**CERTIFICATE OF APPROPRIATENESS**

**Property:** 824 W Temple St, Lot 4, Block 218, East Norhill Subdivision. The property includes a historic 1,644 square foot, one-story single-family residence and a detached garage situated on a 5,512 square foot interior lot.

**Proposal:** Alteration – Remove a non-original single-pane window and install two new vinyl, 1-over-1 windows in the opening; remove a non-original vinyl window and enlarge the opening to install two new 1-over-1 vinyl windows.

**Recommendation:** Approval

WEST SIDE ELEVATION

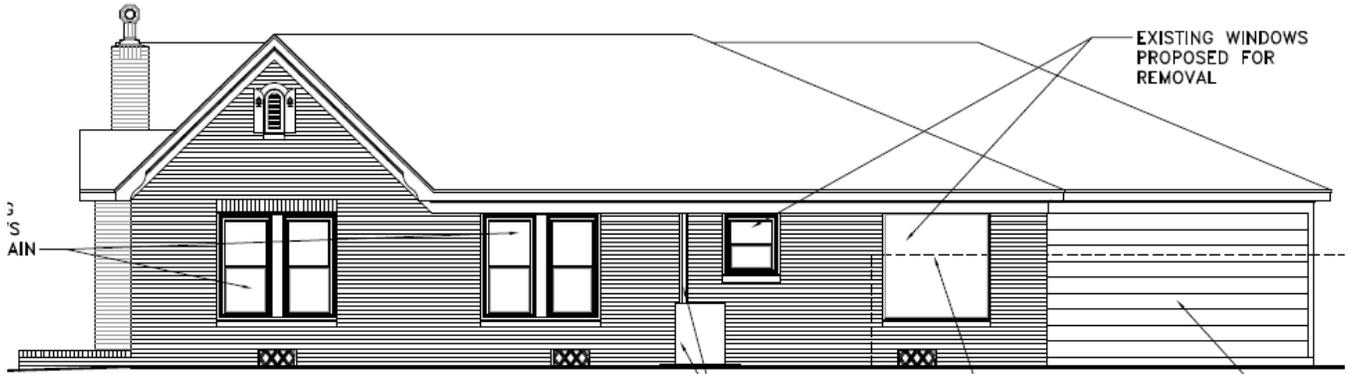
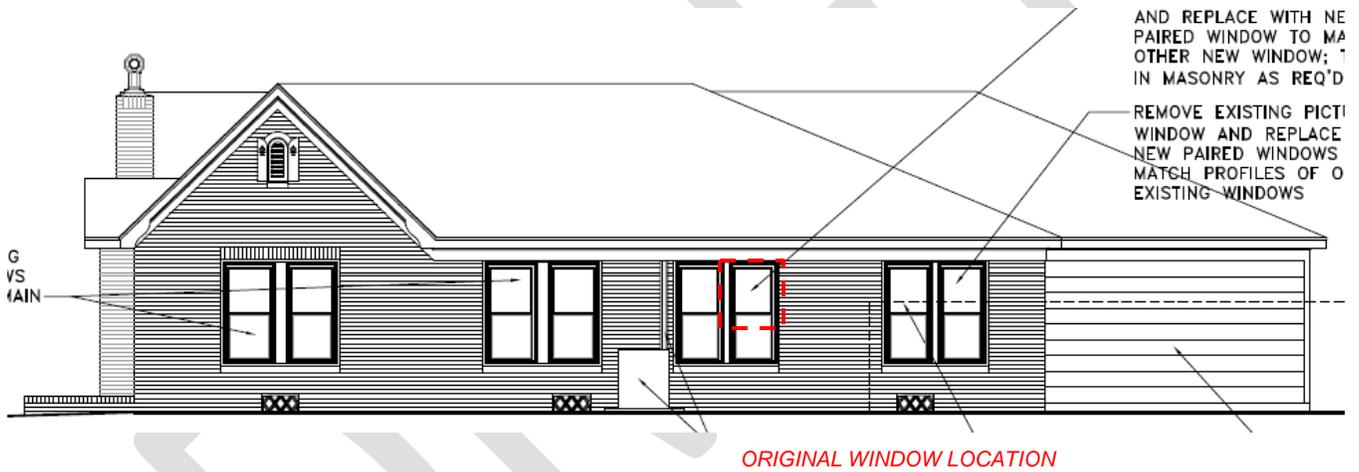
**Side Elevation:** This elevation contains a 5'-7 1/2" wide by 5'-6 3/4" tall aluminum window and a 2'-10 1/2" wide by 3'-2 1/2" tall vinyl 1-over-1 window. The aluminum window will be removed and two 1-over-1, double-hung vinyl windows will be installed in the same opening to match the existing residence. The windows will be mounted within the existing wood frame without fins and a new mullion will be installed. The smaller vinyl window will be removed and the opening enlarged to 5'-7 1/2" wide by 5'-6 3/4" tall to accommodate two 1-over-1, double-hung vinyl windows. A new 1 5/8" subframe and mullion will be installed and reclaimed bricks will be used to form a matching sill.
